232-242 DANFORTH STREET

# APPLICATION FOR PERMIT

# APPLICATION FOR PERMIT

57I-1, 2, 3+4

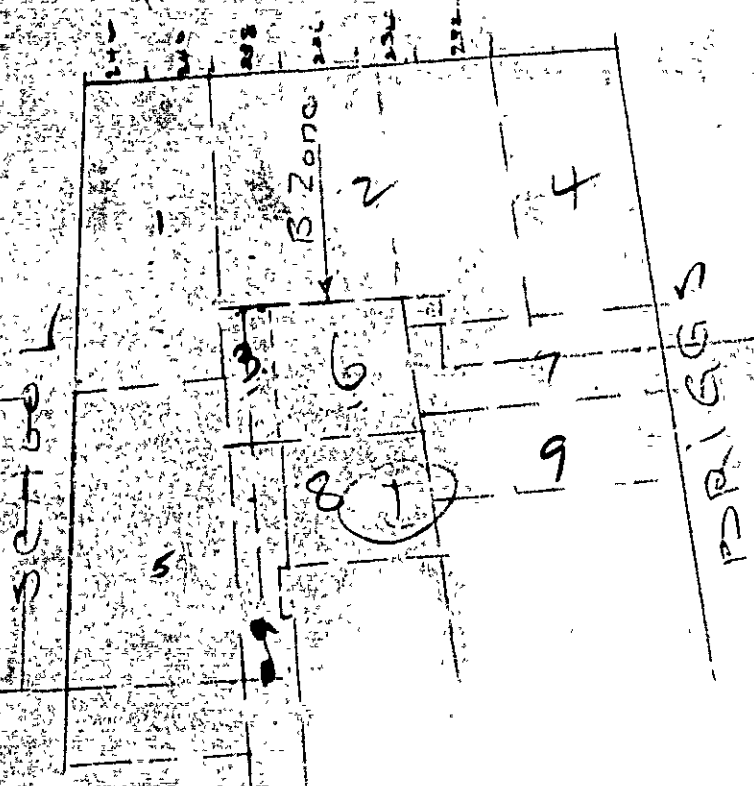
1. A revised plot plan bearing indication of approval of City Traffic Engineer as regards the driveway approaches to lot and of the Director of Parks and Recreation as to the removal of any trees within the limits of the public street is needed. Since the appeal under the Zoning Ordinance was sustained upon the condition that the service station use shall be restricted only to such portions of the land involved as are within 100 feet of Danforth Street, the area to be so used should be indicated clearly on this revised plot plan also.

12. The 2x8 rafters 16 inches on centers on a 14-foot span do not figure out to provide the required live load of 40 pounds per square foot if dressed hemlock or spruce lumber is used.

Reference is made to item 12 of Mr. Sears's letter. It is our intention to change the 2 x 8" rafters shown on the plans to 2 x 10" rafters, 16" on centers.

- Item 1: Attached is a revised plot plan upon which is indicated the limitation of the development which will not exceed a depth of 100' from Danforth Street as directed by the Zoning Board of Appeal. The approval of the City Traffic Engineer in regard to driveway approaches to the lot and the approval of the Director of Parks and Recreation as to the removal of any trees within the limits of the public street will be obtained prior to the construction of driveway approaches or removal of any trees. ✓
